# UNITED STATES PATENT AND TRADEMARK OFFICE

10/743,734

| <b>Office Action Summary</b> | <b>Application No.</b> | <b>Applicant(s)</b> |  |

## DETAILED ACTION

**FIG. 1**

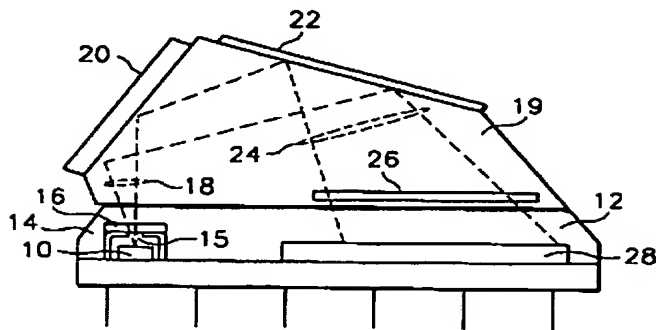
Keller et al. (503) discloses a multiwell (Fig. 1, Ref. 22), wherein the detection chip is configured to be detachable (Col. 3, lines 4-7) relative to an optical unit unitarily including a light supply means (Fig. 1, Ref. 10) and a light detection means (Fig. 1, Ref. 28); and a light path (See dotted lines in Fig. 1) in the detection chip charged with a first material (Fig. 1, Ref. 12) and another portion in the detection chip charged with a second material (Fig. 1, Ref. 19) having a different refractive index from the first material (Col. 3, lines 4-10).

Applicant takes the position on page 8-9 of the Remarks/Arguments that the reference of Keller that the housing in not in the detection chip and therefore, does not disclose a light path in the detection path in the detection chip charged with a second material having a different refractive index from the first material. The examiner takes the position that the reference of Keller shows the claimed invention, wherein the light path in Keller is disclosed by the dotted lines in figure 1. The first material being the base housing 12 made of an optical material, which transmits radiation and the second material being the detachable optical housing 19 made of a material different or a same material as the base housing 12. It is inherent in the optics art that two different materials are going to refract light different than air, therefore if the housing of 12 and 19 are made of a different material then the refractive index will be different. It is therefore concluded the reference of Keller reads on the claimed limitations.
